# Recall Campaign Bulletin

Campaign No. 2022050011, May 2022

SUBJECT: **Model GLB-Class (247 platform)**  
**Model Year 2021**

## **Check Level Sensor Linkage Rear Axle**

Figure 1

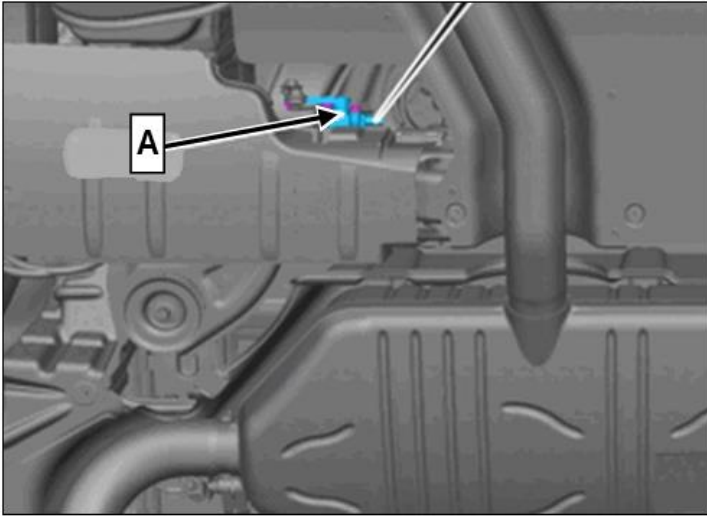
2. Check installation position of link rod of right rear axle level sensor (**A, figure 1**).

Figure 2 (OK picture)

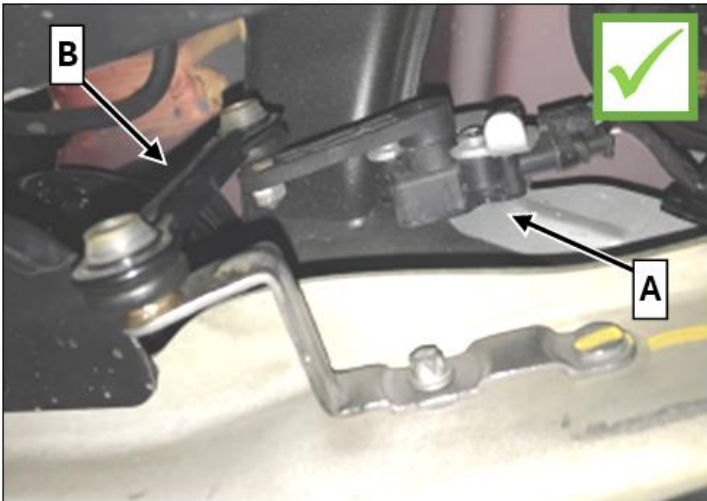
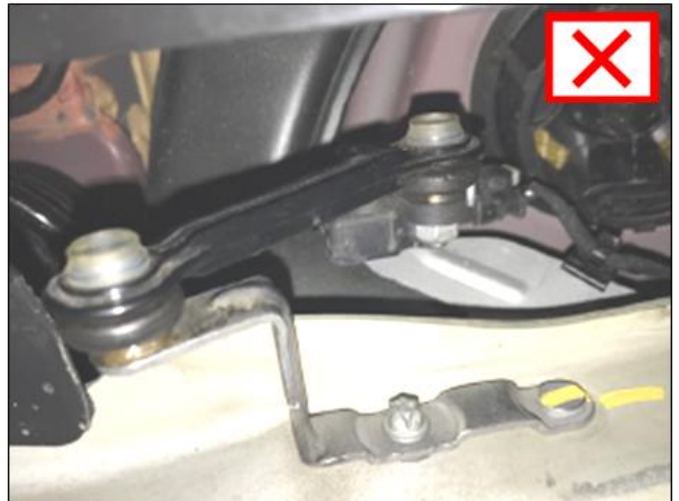
**i** The installation position of the link rod (B) of the right rear axle level sensor (A) must be installed as shown in figure 2 (**OK picture**)!

**i** The figure 3 (**not OK picture**) represents an **incorrect** installation position!

- a. If the **Installation position** of the link rod is **not OK**: Carry out **work procedure**.
- b. If the **installation position** of the link rod is **OK**: **End measure**.

1. Release link rod from the right rear axle level sensor.  
i For basic data, see AR82.10-P-0005MFA.
  2. Position the link rod and right rear axle level sensor.  
i Spacer ring is seated directly under the connecting flange of the upper oil line!
  3. Secure link rod of the right rear axle level sensor.  
i For basic data, see AR82.10-P-0005MFA.
  4. Perform function test of automatic beam range control.  
i For basic data, see AP82.10-P-8250EW.
-
